**SECTION 4.55(1A) MODIFICATION APPLICATION (SSD-9671)  
YOUNG HIGH SCHOOL LIBRARY AND JOINT\_USE COMMUNITY FACILITY**

This application has been prepared by Ethos Urban on behalf of NSW Department of Education, School Infrastructure NSW (SINSW) pursuant to section 4.55(1A) of the *Environmental Planning and Assessment Act 1979* (EP&A Act) to modify State Significant Development Consent SSD-9671 relating to Young High School Library and Joint-Use Community Facility at 9 Campbell Street, Young (the site).

**Figure 2** Proposed Tree Protection and Removal Plan for Carrington Park (modifications are clouded)

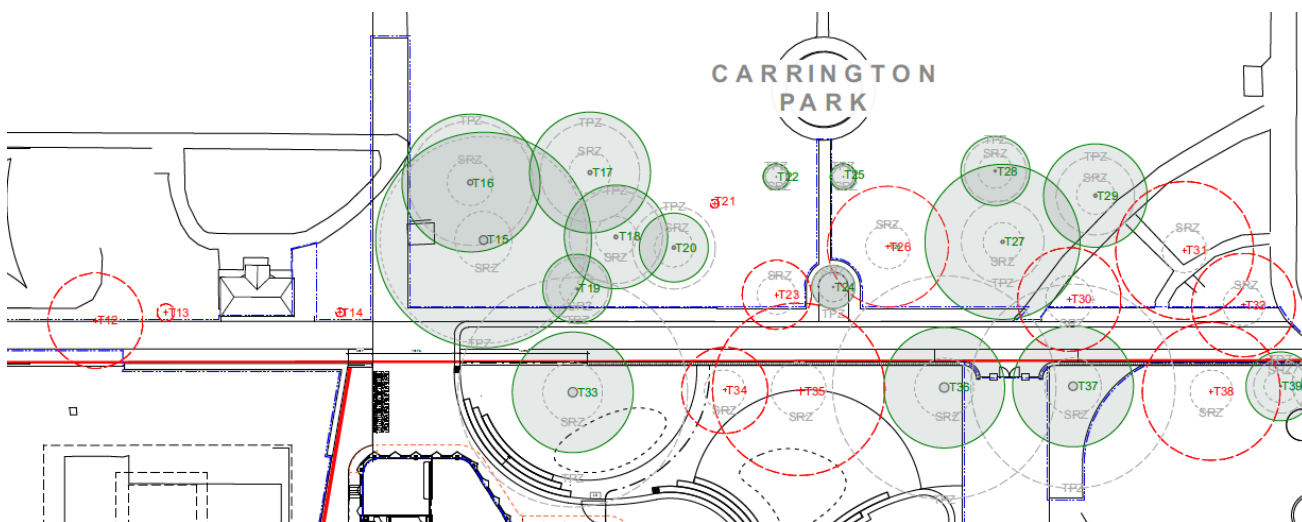
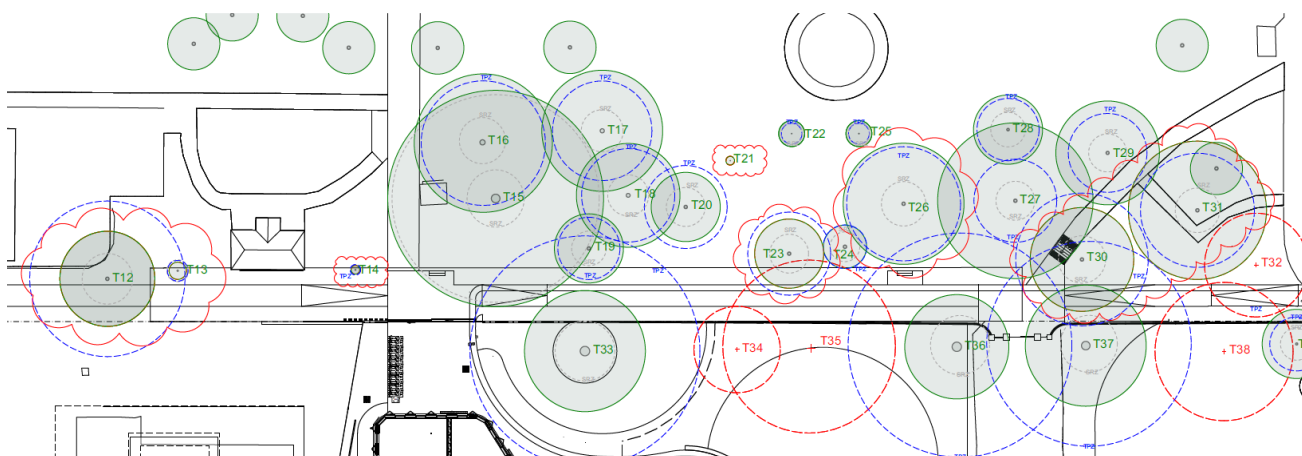
Hilltops Council requested the retention of additional trees within the council owned Carrington Park. Under the SSSDA approval, these trees were nominated for removal at the request of Heritage NSW to enable improved sight lines from the Park to the heritage listed courthouse. The retention of these trees will minimise the development's impact on Carrington Park. The trees approved for removal under the SSSDA consent now proposed for retention include:

- Tree 12 - Grevillea Robusta Silky Oak;
- Tree 13 - Ulmus glabra lutescens Golden Elm;
- Tree 14 - Ulmus glabra lutescens Golden Elm;
- Tree 21 - Ulmus glabra lutescens Golden Elm;
- Tree 23 – Picea pungens Blue Spruce;
- Tree 26 - Cedrus deodara Himalayan cedar;
- Tree 30 - Eucalyptus cinerea - Argyle Apple; and
- Tree 31 - Cedrus deodara Himalayan cedar.

Council will take full ownership of the ongoing maintenance and safety of these trees in Carrington Park. A Letter of Support has been prepared by Hilltops Council (**Attachment D**). A comparison of the SSDA approved Tree Protection and Removal Plan and the proposed Tree Removal and Protection Plan for Carrington Park is shown in **Figure 1** and **Figure 2**.

**Figure 3 Proposed path and pavement modifications in Carrington Park**

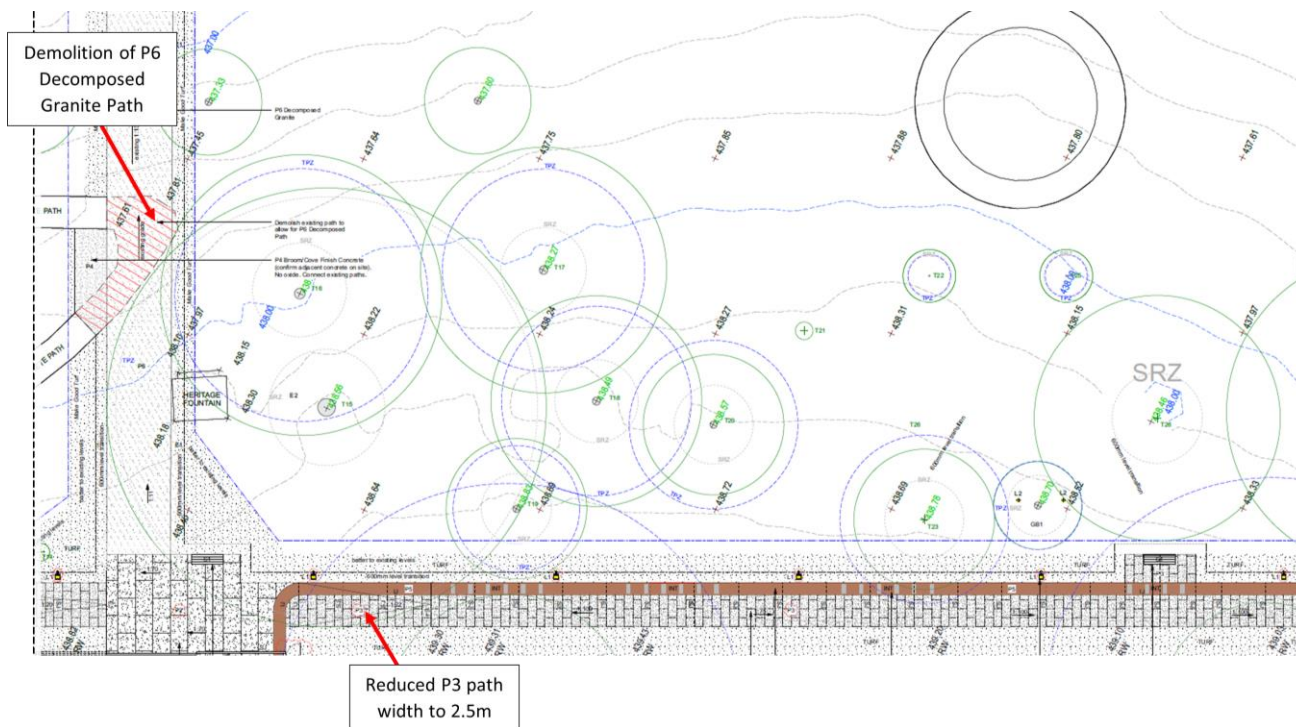
To help minimise the proposed development’s impact on Carrington Park, a range of amendments are proposed to the approved paving and paths. Changes include the retention of the path to the TAFE entry; the P3 path located in front of Carrington Park width is to be reduced to 2.5m, and removal of the P6 Decomposed Granite path located in Carrington Park. These amendments to the proposed paving and paths have been requested by Hilltops Council, as these additional works are no longer required and will minimise the impact of the development on the park.

In addition, the proposed path (P6) is to be removed surrounding the Reconciliation Tree, as the Project Arborist has advised the originally approved proposed works would likely cause damage to the Reconciliation Tree. Council has also advised no works are to be undertaken near or around the Reconciliation Tree, to prevent damage to the tree roots and minimise the impact to the park. Furthermore, the existing path from the Waterwise garden is to be

demolished and the stairs connecting to the existing path near the Waterwise Garden is to be amended, in order to achieve compliant grading of paths as required as per Australian Standard 1428.1.

An excerpt of the proposed modifications to the paths and paving located in and near Carrington Park is shown in **Figure 3**. Refer to the landscape plans L-103, L-104 and L-105 to view the detailed extent of the changes to the paths in Carrington Park.

**Figure 4 Proposed refinement of seating in Carrington Park**

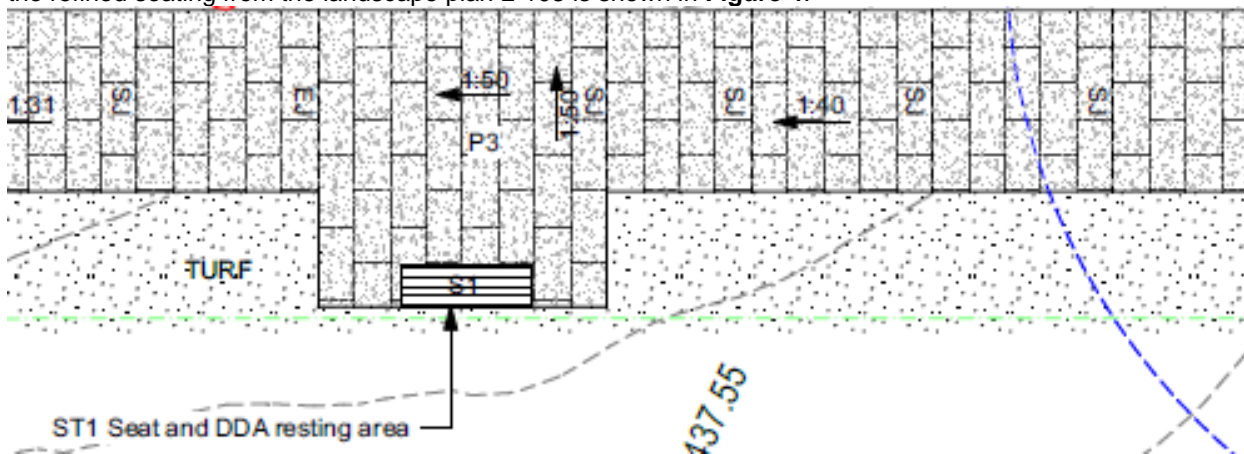
The proposed seating along the path adjoining Carrington Park is to be removed, as the Park already provides adequate seating. A single seat is to be retained in the middle section of the path and has been refined to satisfy Disability Discrimination Act (DDA) 1995 compliance for seating/resting areas every 60m as required. An excerpt of the refined seating from the landscape plan L-103 is shown in **Figure 4**.

**Figure 5 Proposed relocation of lighting**

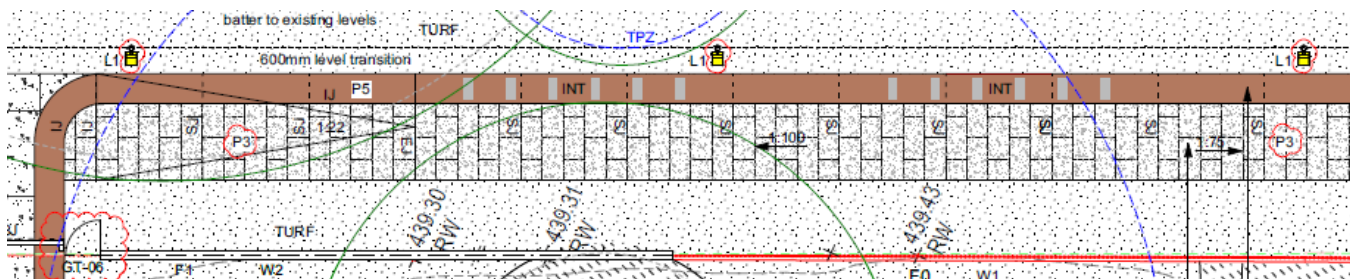
The L1 lights are to be relocated to the northern side of the path in order to avoid Tree Protection Zones. The light has also been relocated to avoid trenching electrical conduit near the existing heritage fence. An excerpt of the landscape plan L-104 highlighting this change is shown in **Figure 5**.

**Figure 6 Proposed tree removal in internal school quadrangle**

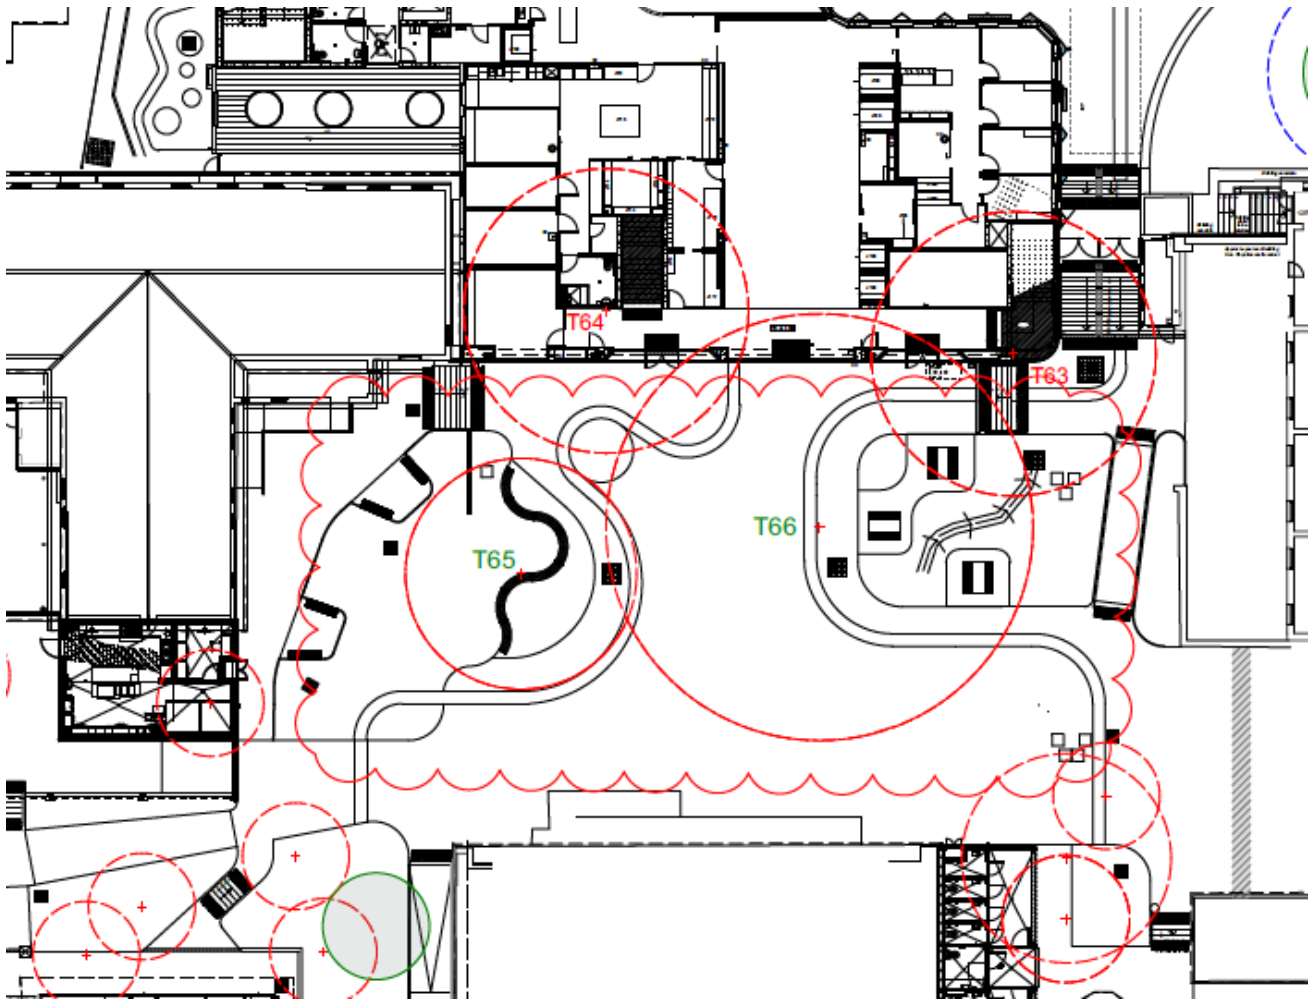
The two existing trees (T66 – Lemon Scented gum and T65 – Chinese elm) located in the internal school quadrangle are proposed to be removed due to the original landscape design requiring half of the tree foliage to be trimmed in order to accommodate the construction of Block NN. Further to this, the other half of the tree foliage would need to be trimmed to balance the tree, this would likely cause the tree to not survive, and if it did it would stunt its ongoing regrowth. Additionally, the original landscape design required the construction of an elevated wooden frame above the tree roots and significant pruning being required to erect scaffolding for the new library. After review from the Project Arborist, it was noted the post holes which would be required for the elevated wooden deck would damage the tree roots and kill the tree. A Letter of Support has been provided by the Project Arborist (**Attachment C**), which supports the removal of the existing trees due to the significant excavation works required in proximity to the trees, resulting in minimal survival. A revised Tree Protection and Removal Plan has been prepared by 360 Degrees as part of the revised landscape plans at **Attachment A**, an excerpt of the plan identifying the trees proposed for removal in the internal school quadrangle is shown in **Figure 6** below.

In lieu of the removal of trees, additional garden beds are proposed, and 10 additional semi mature trees will be planted within the internal courtyard to compensate for the loss of tree canopy and shading. The Arborist Statement details the remaining trees within close proximity of excavation works are to be soil injected with fertiliser and ongoing inspection for root damage will be undertaken. For the garden beds, Young High School has requested the new garden beds be raised, to delineate the gardens from the play area/walkable area to prevent students from walking through the gardens. By including raised garden beds it will also prevent mulch in the garden beds from being spread across the playground.

**Figure 7 Proposed amended landscape design for internal school quadrangle**

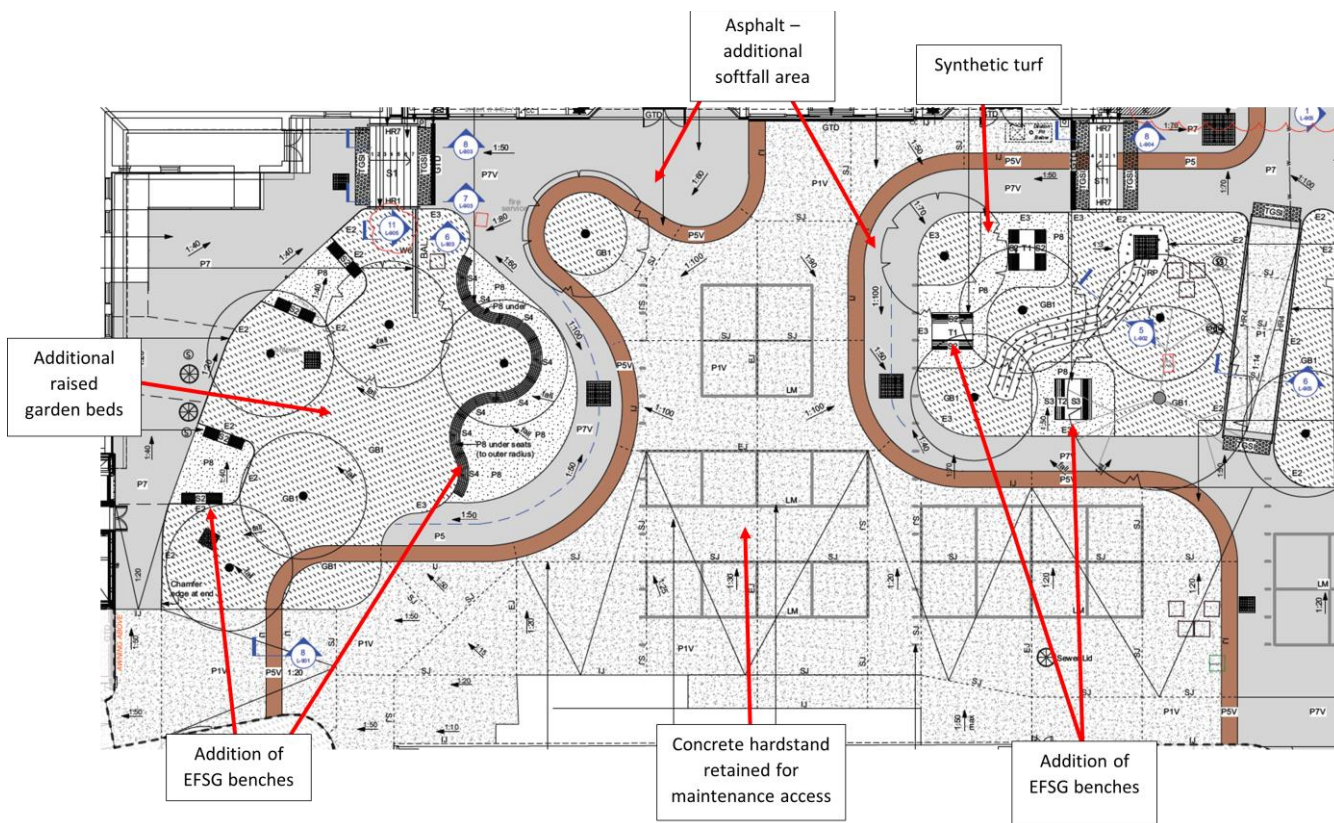
As a result of the proposed removal of the existing trees a redesign of the current playground is required. The redesign of the playground involves the removal of the proposed wooden deck, the extent of the concrete amended, and asphalt introduced, and addition of Educational Facilities Standards and Guidelines (EFSG) compliant bench seats and tables. These changes will allow for additional open space area for students and additional seating space. The introduction of asphalt and extent of the concrete being amended was at the request of Young High School wanting additional Softfall areas for student seating and congregation during school break times. It is to be noted, as a result of the proposed development the only open hardstand area remaining on site is the school playground, this has been retained to enable roof maintenance access for craneage during construction, as craneage is not possible from Carrington Park. As a result of the softfall and concrete redesigns, the stormwater and grated trench drains are proposed to be amended.

Educational Facilities Standards and Guidelines (EFSG) compliant bench seats and tables have been added as part of the playground redesign to provide Young High School with additional seating options for students during lunch and recess. Furthermore, the redesign of the playground includes the addition of synthetic grass within the playground.

The amended internal courtyard design is shown at **Figure 7**.
